Applicant(s): James N. Ray Art Unit: 1762
Serial No.: 10/726,358 Examiner: Brenda Adele Lamb
Filing date: December 3, 2003
For: CELLULOSE PRESERVATIVE METHOD AND APPARATUS

REMARKS

ANNOTATED SHEET

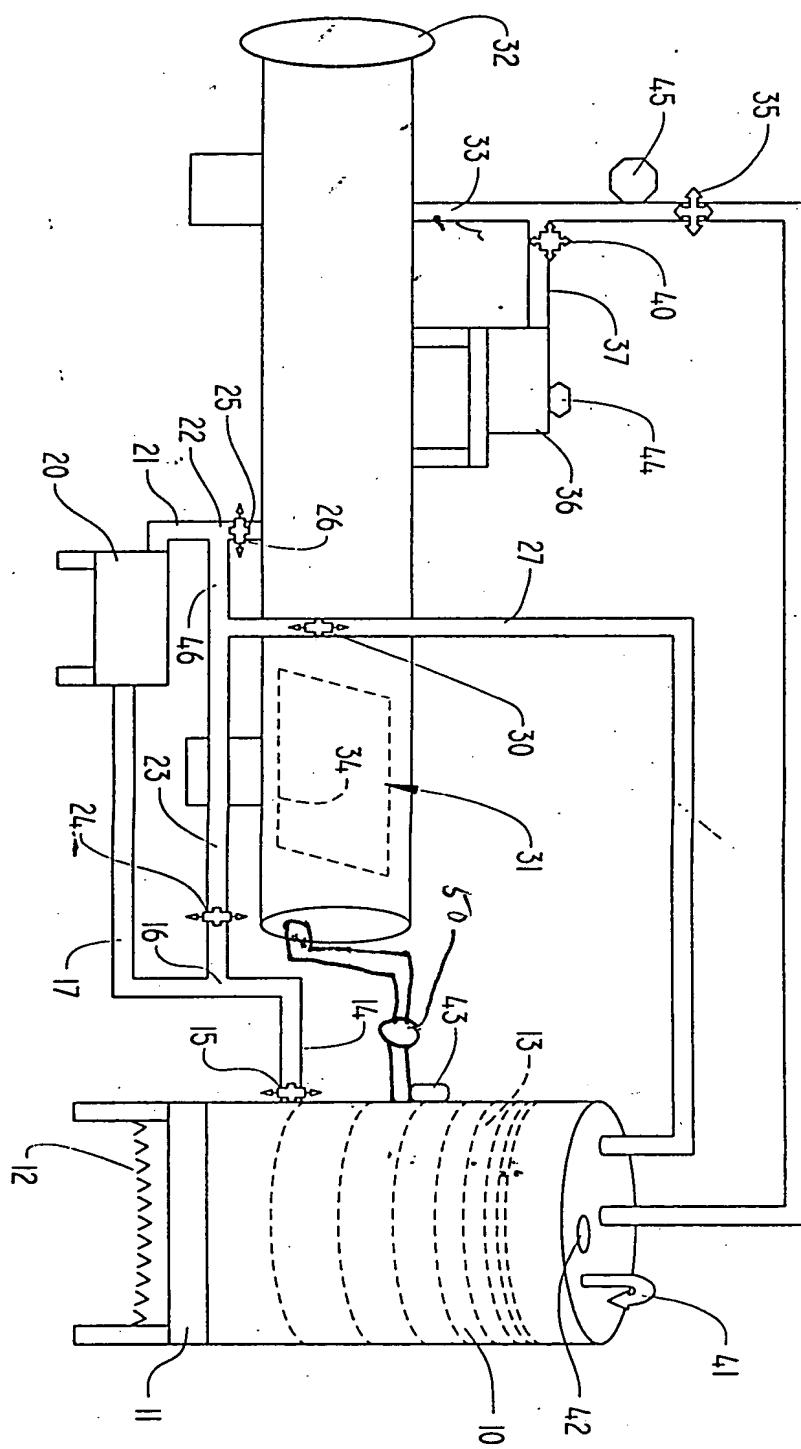
In response to the Examiner's request under 37 C.F.R. §1.83(a) for an amendment to the drawing in the application as filed that will show a discharge pump for selectively withdrawing fluid from the pressure vessel and returning fluid to the work tank, attention is invited to the drawing Replacement Sheet and the companion Annotated Sheet submitted with this response in accordance with Manual of Patent Examining Procedure Section 608.02(v). As now illustrated in the sole figure of the drawing, a pump 50 is connected from the pressure vessel 31 to the work tank 10. As described in the application when filed, at page 10, lines 1 through 4:

In the Replacement Sheet, a pump 50 has been added between the pressure vessel 31 and the work tank 10 to provide this transfer function and the corresponding paragraph in the specification has been amended to reflect the addition of the reference numeral 50.

...a separate discharge pump 50 to evacuate the mixture from
the pressure vessel 31.
